## Product Change Notification / SYST-15VVG953

ERRATA - PIC32MZ Embedded Connectivity with Floating Point Unit (EF) Family Silicon Errata Document Revision

## PIC32MZ Embedded Connectivity with Floating Point Unit (EF) Family Silicon Errata and Data Sheet Clarification

**FIGURE 1: Posc CRYSTAL CIRCUIT**

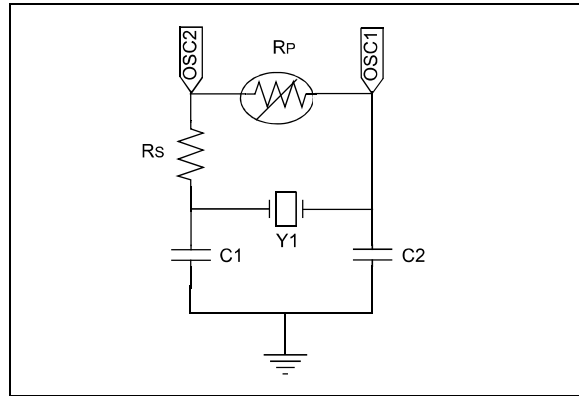
**Revision A1 Silicon:** A crystal oscillator cannot be used as an input to the Primary Oscillator (Posc) pins OSC1 and OSC2.

**Revision A3 and B2 Silicon:** The POSC has been tested in a normal power-up sequence and supports specific crystal operation.

The Primary Oscillator (Posc) has been characterized to operate at 8 MHz, 12 MHz, and 24 MHz when the circuit in [Figure 1](#) is implemented, and the operating conditions listed in [Table 3](#) are met.

- Note 1:** Using any other crystal frequency will require special component selection and characterization.  
**Note 2:** A parallel resistor (Rp) should not be used to increase the gain of the POSC.

## 64-PIN QFN<sup>(4)</sup> AND TQFP (TOP VIEW)

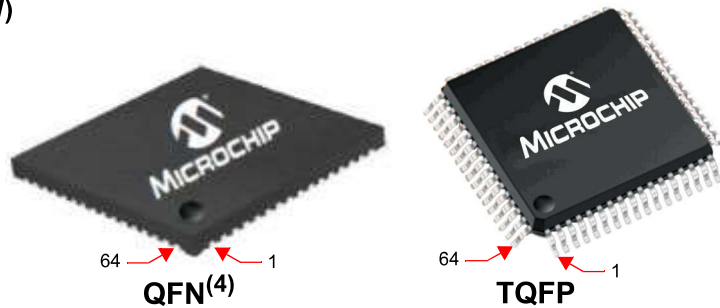
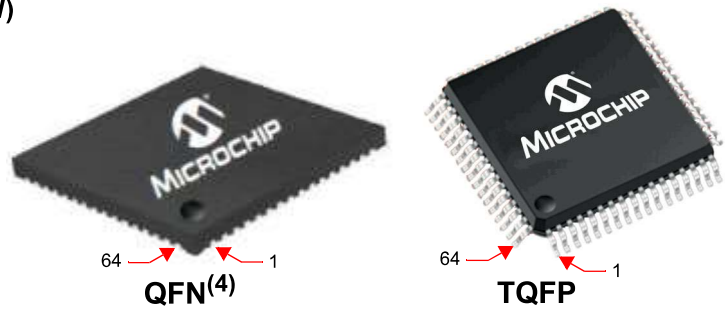
In Table 2. “Pin Names for 64-pin QFN and TQFP Devices” of the current data sheet, the AECRSDV signal was erroneously omitted from the pin number 44 and added to the pin number 62. The correct assignment is shown in bold type in the following table.

In 64-pin QFN/TQFP column of Table 1-19, “Alternate Ethernet RMII Pinout I/O Descriptions” of the current data sheet, the AECRSDV signal was erroneously assigned to the pin number 62 instead of the pin number 44. The correct assignment is shown in bold type in the following table.
